Title: Evaluation of Proposed Blast Tube Rehabilitation Measures - 30% design

Evaluation of Proposed Blast Tube Rehabilitation Measures – 30% design

Analysis effort conducted to meet request for 30% rehabilitation design evaluation.

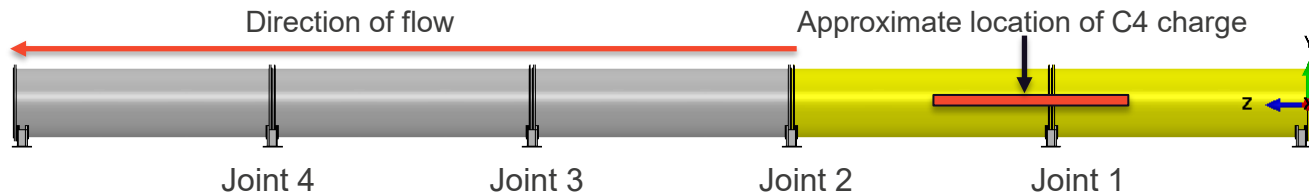
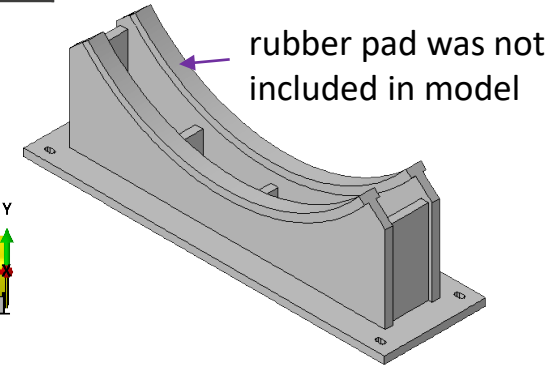
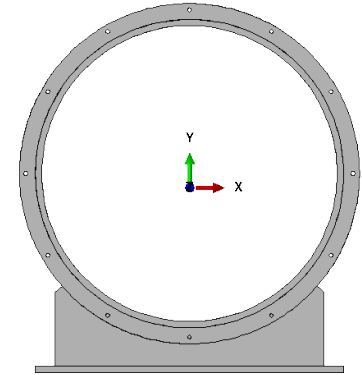
Suggested retrofits seek to remove constraints on facility and allow structural compliance.

- Axial footings replaced with saddles
 - Facility is supported only at tube joints
- Tied 3DOF saddle contact to ground
 - Exact grounding approach undefined
- Two models studied
 - Tube sections flush contact
 - $\frac{1}{4}$ " gaps intentionally introduced into layout

deformation magnitude: x100
5.9 ms post-detonation

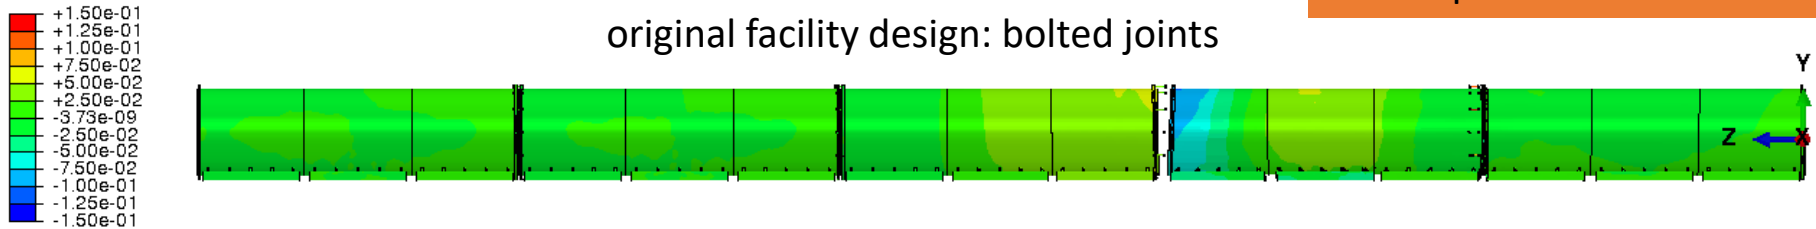
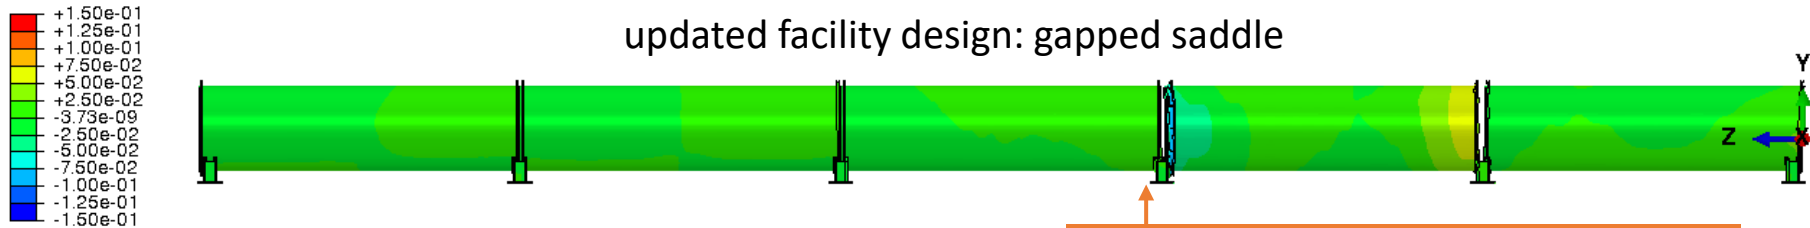
Introduction of 1/4" gaps show significant difference in facility axial response

No visual evidence of tube collision

Axial Motion at Facility Joints

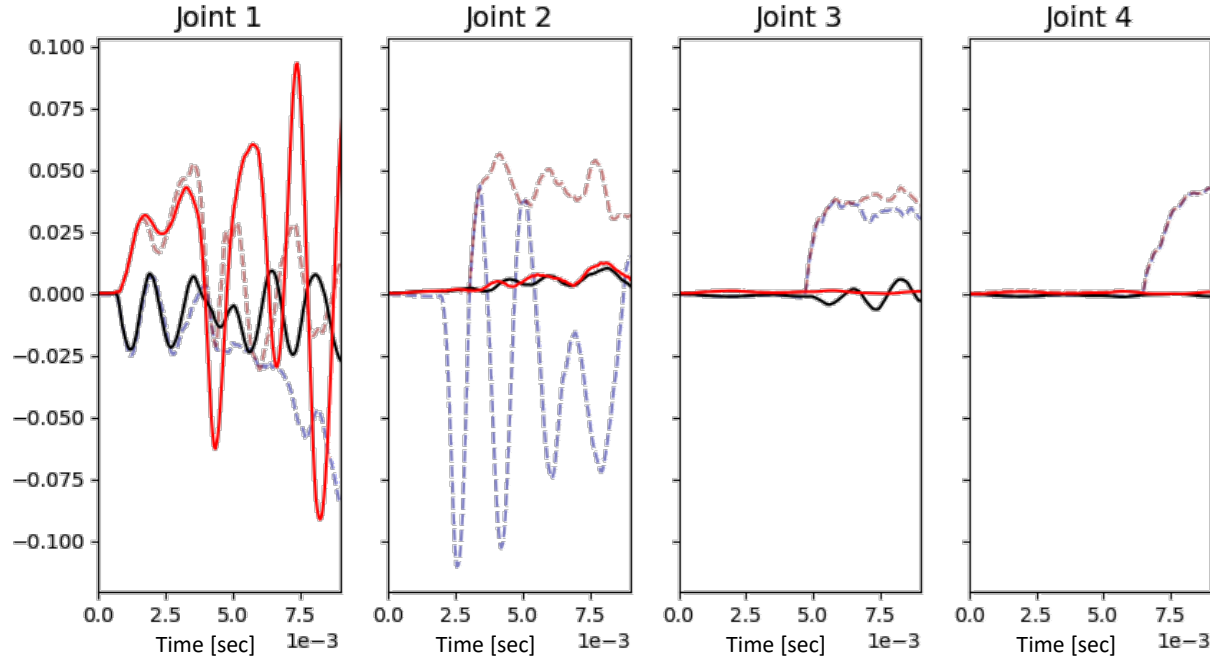
1/4" gap between tube sections alleviates contact between tube sections

- Spacing of tube section eliminates interference
 - contact is not seen due to gap
- minimal downstream movement
 - gap may be unnecessary for downstream sections

Motion of Tube 2: 50' from breech

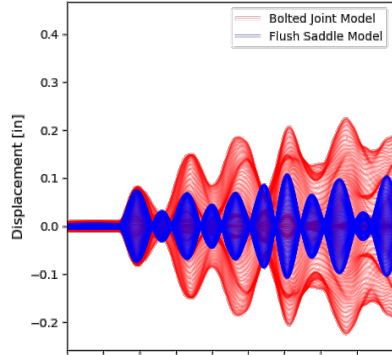
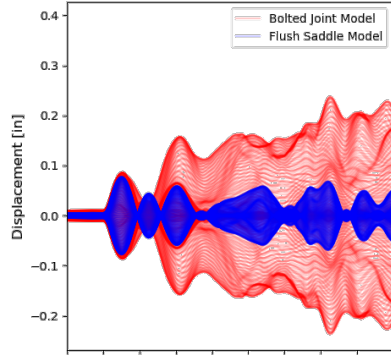
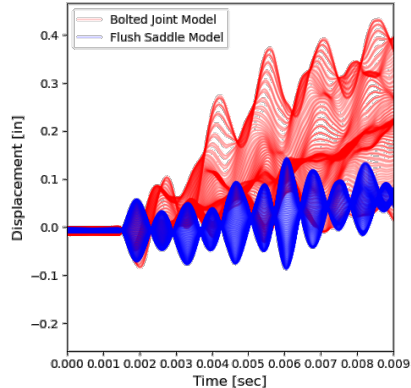
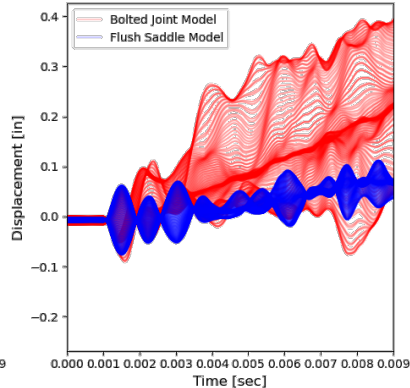
Significant changes in radial displacements noted

- Displacement at joints have been attenuated
 - Hypothesis that more energy is going into the overall radial expansion of the tube sections
- Tube 'jump' has also been attenuated
 - Location of reaction forces has shifted to saddles
- Interference of multiple wave patterns suspected.
- Similar initial response of models speak to consistent input conditions.
 - Boundary conditions effect later responses.

Motion of Tube 2: 50' from breach

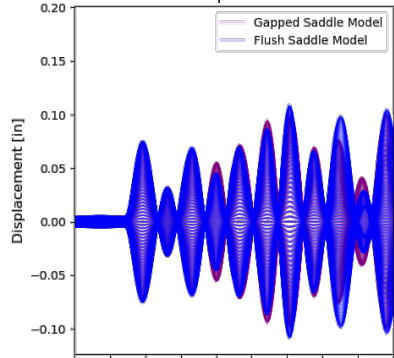
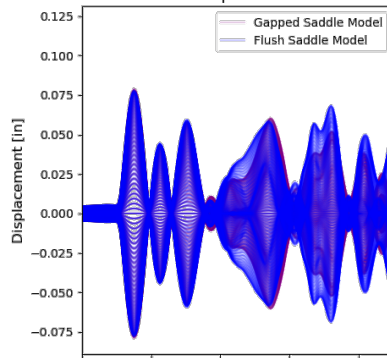
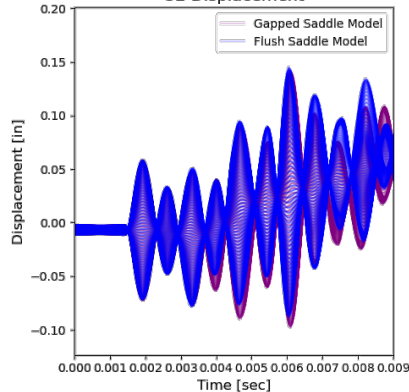
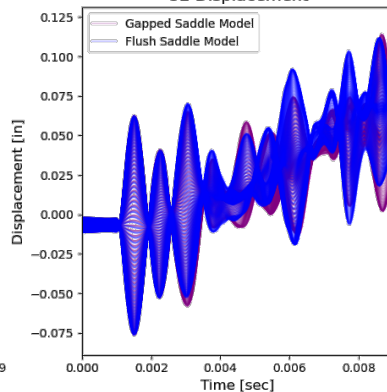
Minimal change in radial response seen between the saddle designs.

Flush design does lead to multiple wave signals

- Time signals are largely consistent
 - Loading is dominating tube response
- Later time response (4ms) shows variability
 - Hypothesis of multiple waves moving through tube after impact in flush design
- Interference of multiple wave patterns suspected.
- Similar initial response of models speak to consistent input conditions.
 - Boundary conditions effect later responses.

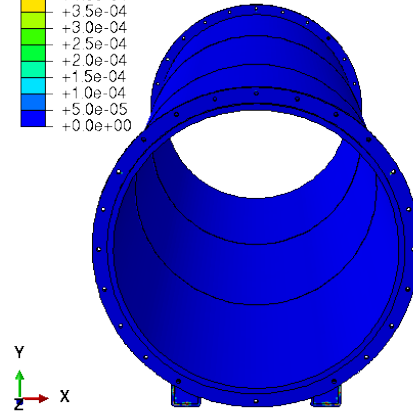
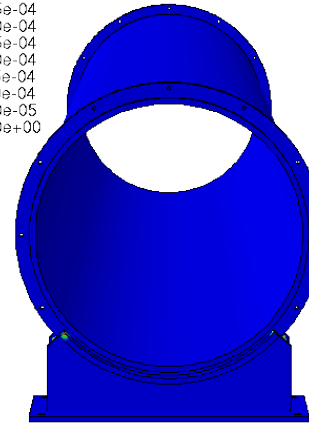
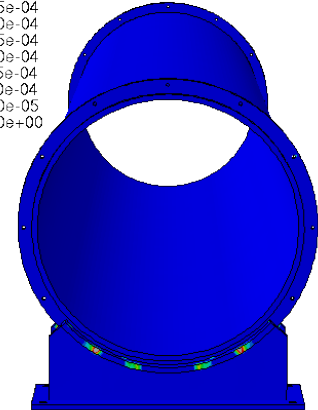
Material yielding is still present in facility with proposed rehabilitations.

Plasticity noted in the saddle

Plasticity in the tube section is not seen for current facility design and proposed rehabilitations.

- Model that resulted in plasticity of the tubing had several considerations
 - Like materials for both the tube and footing designs.
 - Stress bridges placed at Joint 1 of the facility

Reaction Forces at Facility Joints

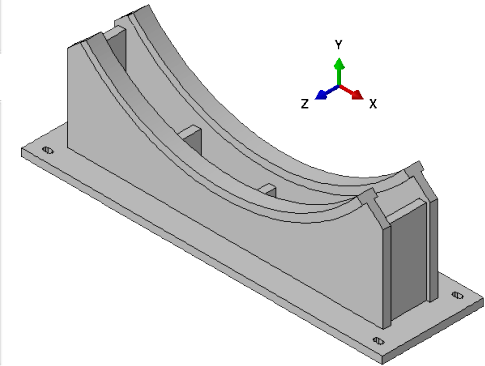
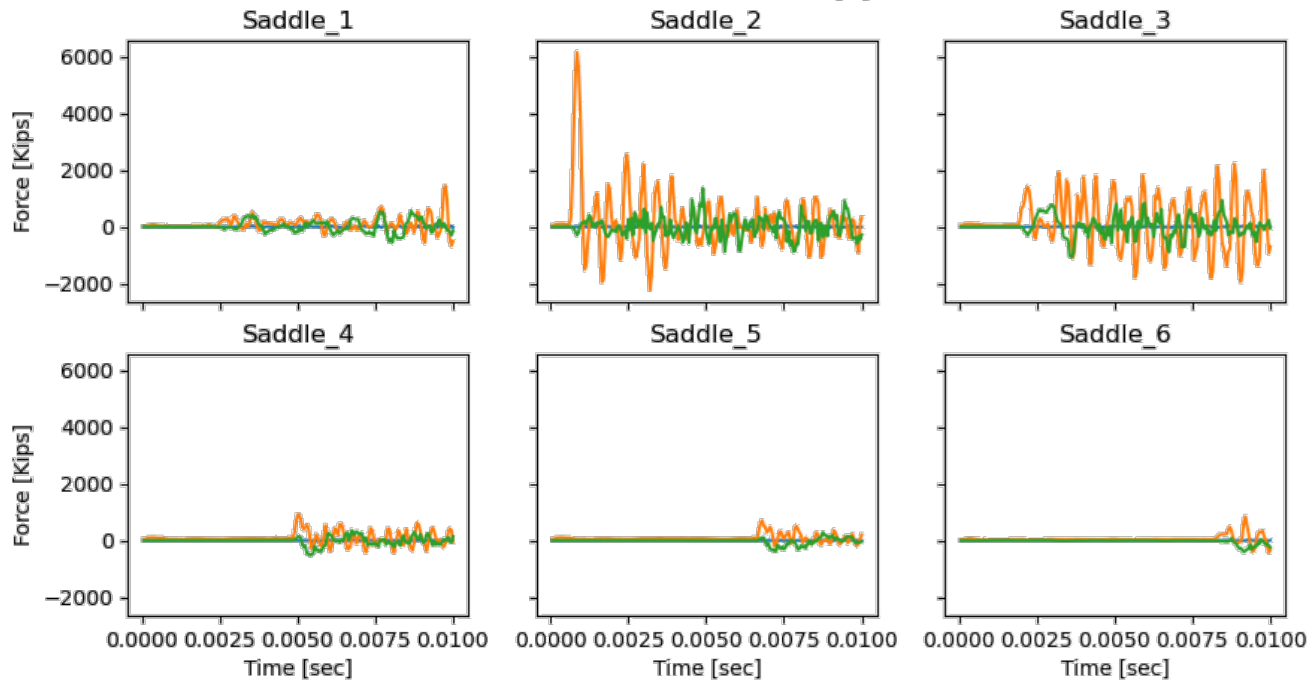
Reaction forces were evaluated for the flush saddle design. Model shows high forces at Joint 2 support

Updated facility design: Flush Saddle

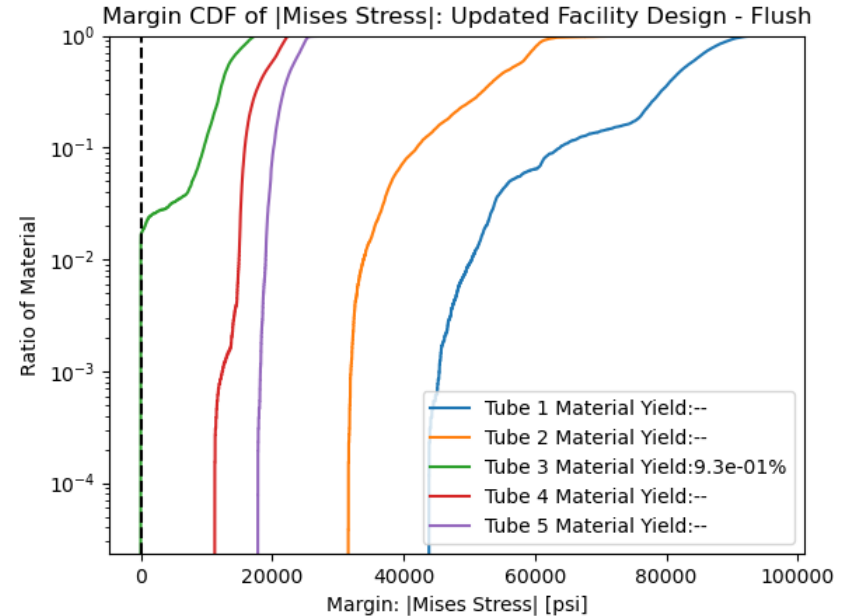
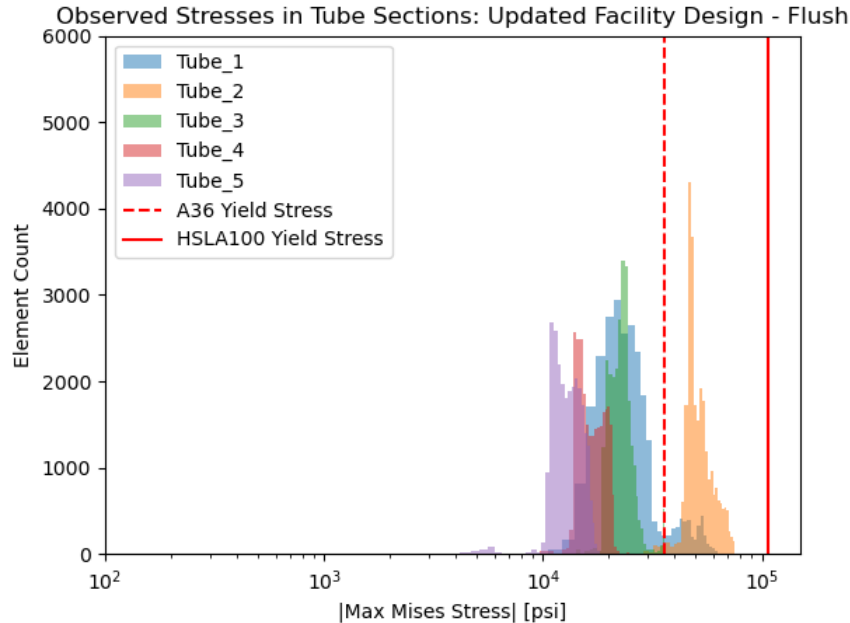
Magnitudes of $|\text{mises stress}|_{\text{max}}$ in flush tube design show higher stresses in bulk material

- Maximum stresses in HSLA100 tubes show increase $\sim 5\%$
- Maximum stresses in A36 tubes increase by an average 2%

Updated facility design: Gapped Saddle

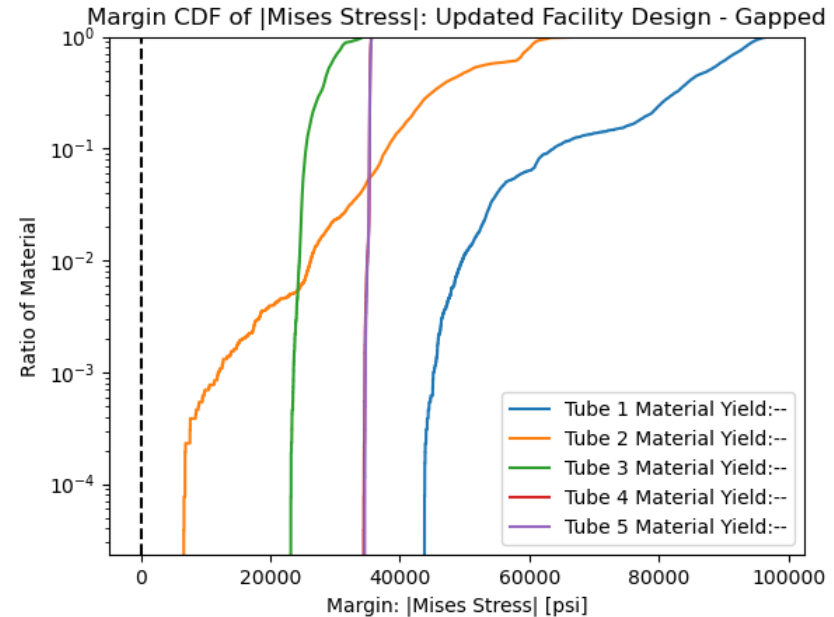
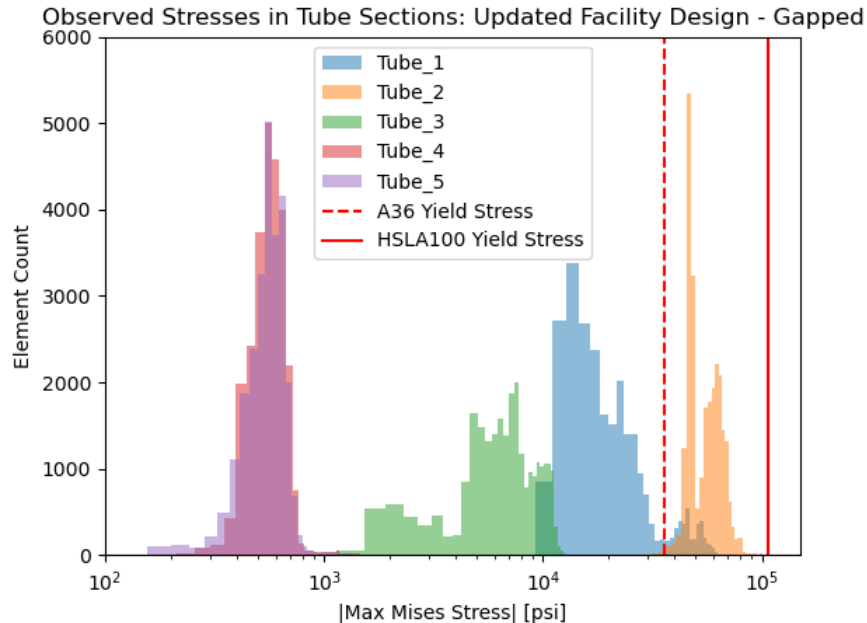
Magnitudes of $|\text{mises stress}|_{\text{max}}$ show changes to tube response if gaps are introduced

- HSLA100 tube sections show minimal change in maximum stress
- A36 tube sections see dramatic decrease in max stresses ~ 83% drop
